Stair flip study · the main stair turned round: start and arrival at the NORTH end, next to the lift · Taif / Palm House V8.0 (work) · STUDY ONLY

ADOPTED 2 Nov 2026 (owner): option B, the freed landing as F-b, the balustrade, the store door onto the riwaq, the half-landing window, the entrance side light, the entry cupboard removed; applied to the design files. Owner's idea, 1 Nov 2026 · the same well (2.75 × 5.7 on axes, 2.525 × 5.50 clear), the same 22 risers × 0.164 / goings 0.28, flights 1.21 clear · nothing in the design files changes until the owner decides · all sizes assumed

1 · The two options on the ground floor

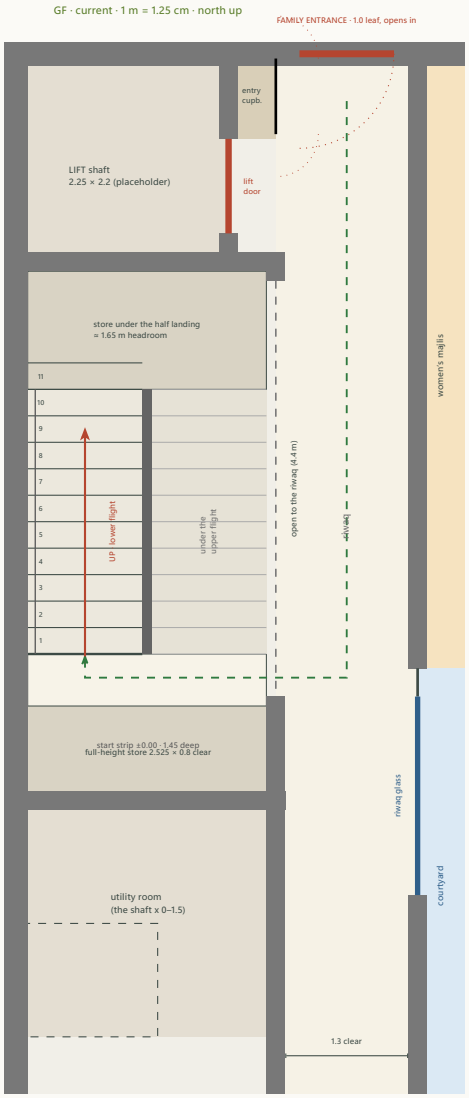
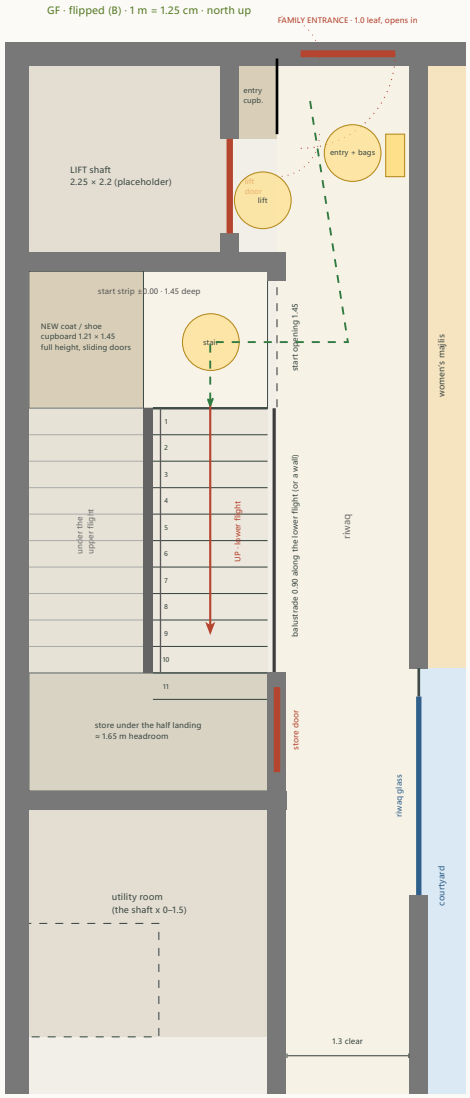
- **Current:** the lower flight on the **west** half starts at the **south** end (first riser y 6.35); the person comes along the riwaq, enters the well through its open east side (4.4 m open) and turns west onto the flight; in front of the first riser only **0.55 m** before the full-height store's wall (the start is really made from the side, under the upper flight's high end). Half landing at the north end (+1.80, a 1.65 m store below it, opening east onto the riwaq); the full-height store 2.525 × 0.8 clear at the south end.

- **Flipped (B, recommended of the two flips):** the lower flight on the **east** half starts at the **north** end (first riser y 3.75), **straight off the lobby**: a 1.45 m opening in the x 2.75 line between the lift notch and the flight, a start strip 1.45 m deep in front of the first riser. The lower flight rises along the riwaq side (a 0.90 balustrade on the riwaq, or a wall: the owner's choice); the half landing at the south end with its 1.65 m store (door onto the riwaq at y 6.7–7.6, in front of the courtyard glass; or into the utility room). The **west half of the start strip** (1.21 × 1.45, full height) becomes a **coat / shoe cupboard** beside the family entrance (sliding doors onto the strip).

- **Flipped (A):** the mirror image only (the lower flight stays west): the person crosses the whole strip to the far half before climbing; no cupboard. Not recommended; everything else below holds for both.

2 · Congestion test at the flipped start (drawn)

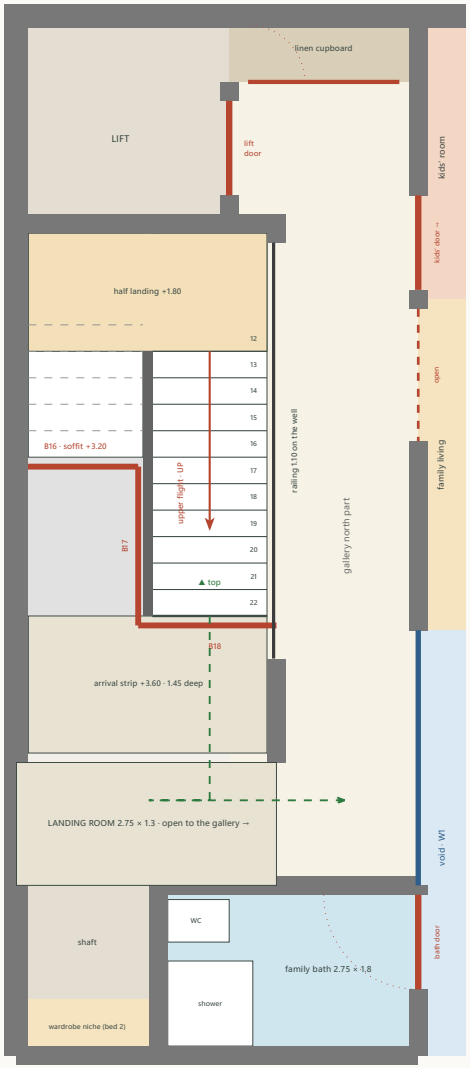
Three people at once: **one waiting for the lift** in the 0.50 m notch in front of its sliding door, **one coming in with bags** inside the family entrance's 1.0 m swing, **one starting up the stair** on the start strip, with the **entry cupboard's two 0.45 leaves open** into the lobby. Clear widths, not axes: the lobby **1.3 m** between the lift / cupboard wall face and the women's majlis wall face (the notch adds 0.5 m at y 0.9–2.2); the start opening **1.45 m**; the first riser **1.21 m** wide; the entrance **0.9 m** clear. The three stand in three separate zones along the lobby (y 0–1.0 the door swing, y 0.9–2.2 the lift notch, y 2.3–3.75 the start strip); the stair starter passes 0.3 m south of the lift waiter and never crosses the entrance swing: **OK**. Two people can pass in the 1.30 m lobby (0.60 + 0.60 + 0.10) but a person with two bags blocks it for a moment, as today. **Furniture up the stair:** the 90° turn from the 1.30 lobby through the 1.45 opening onto the 1.21 flight is a tight but normal house stair turn; the current start (0.55 m strip, sideways) is worse.

FF · flipped (B) · 1 m = 1.25 cm · white = opening · grey = slab

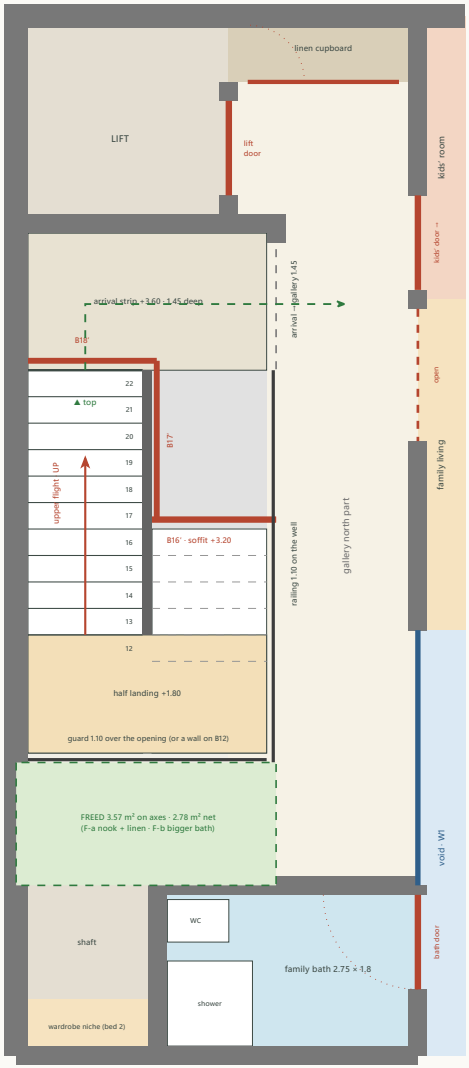
- **Flipped (B):** the upper flight (west half) lands on the arrival strip at the **north** end (y 2.3–3.75); the strip opens east onto the gallery's north part (1.45 m), **0.10 m south of the lift notch**: the lift's first-floor door, the linen cupboard (its leaves swing south, 0.6 m), the kids' room door (opens into the room) and the family living's opening are all within 1–3 m. The gallery's north part (1.30 clear) carries the arrival traffic as it carries the lift's today; the linen leaves and the lift door are 1.0 m north of the arrival: no clash. The railing on the well runs from the arrival (y 3.75) to the south wall; the landing room is **freed** (§ 5).

- **Flipped (B):** the **same opening turned round** (≈ 8.2 m²): the east half open from B16′ (y 5.33) to the south wall, the west half from B18′ (y 3.65) to the south wall. **B16′** (y 5.33) from the riwaq-line beam B10 to B17′; **B17′** (x 1.49, on the east, lower flight's side of the split: never over the upper flight) from B16′ to B18′; **B18′** (y 3.65, the arrival edge) from the west wall to B17′. The same zigzag, mirrored: one beam-on-beam junction at each end of B17′, the torsion the engineer's; B18′ now bears on the west wall (as B16 does today) and B16′ on B10 (as B18 does today). **Neither better nor worse** for the structure: the spans (1.3–1.6 m) and the bearings are the same kind. **Not verified.**

- **Slab edges:** the arrival strip (1.45 × 2.525) spans between the north wall beam B11 (y 2.2) and B18′; over the lower flight's first six treads the slab spans from B18′ to B16′ (1.6 m) between B10 and B17′. The guard round the opening: the railing on x 2.75 from the arrival south to y 7.9, the well's south wall line y 7.9 (a 1.10 guard or a wall on B12), the upper flight's balustrade on the split.

Headroom · a section along the lower flight for each option · the slab 0.2 thick (soffit +3.32), the trimmers 0.20 × 0.4 (soffit +3.20), the finish 0.08 · over the full walking width of every tread

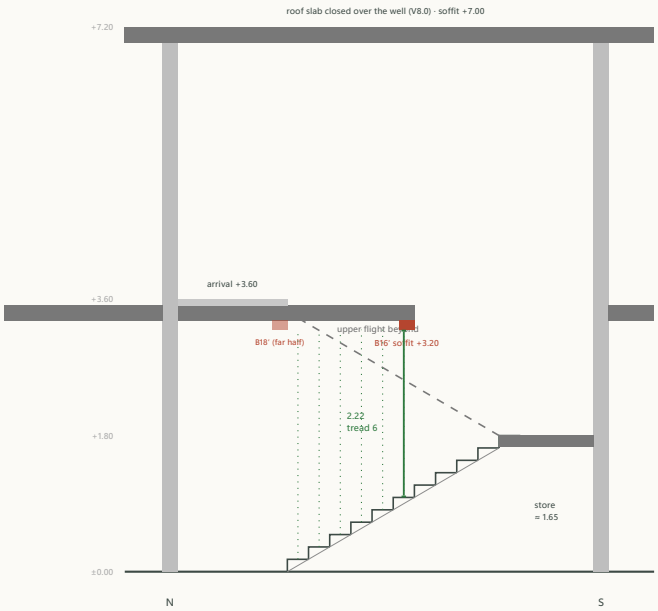
The upper flight, the half landing and the arrival are under the open well (the roof slab's soffit +7.00): ≥ 3.4 m. Minimum of this option: **2.22 m** at tread 6 under the trimmer, across the whole 1.21 m width (the trimmer spans the half); B17 over the inner 0.10 strip of treads 1–5: ≥ 2.38 m.

The upper flight, the half landing and the arrival are under the open well (the roof slab's soffit +7.00): ≥ 3.4 m. Minimum of this option: **2.22 m** at tread 6 under the trimmer, across the whole 1.21 m width (the trimmer spans the half); B17′ over the inner 0.10 strip of treads 1–5: ≥ 2.38 m.

Verdict on the headroom: identical in both options (**2.22 m** at tread 6 under the trimmer, 2.83 m at tread 3 under the slab; ≥ 2.10 required, the 2.20 aim just met) because the flip mirrors the geometry: the trimmers sit in the same places relative to the treads. **The flip neither improves nor worsens the trimmers.** What would improve both: trimmers 0.20 × **0.30** (soffit +3.30 → **2.32 m** at tread 6) if the engineer accepts a 0.30 depth for the 1.3–1.6 m spans, or the slab edge moved one tread (the opening 0.28 m longer, ≈ 0.35 m² more void, tread 6 under open sky → the minimum moves to tread 5: 2.38 m). Both options can take either. The walls' handrails run the full flights (0.08 off the walls); the central handrail on the 0.10 split.
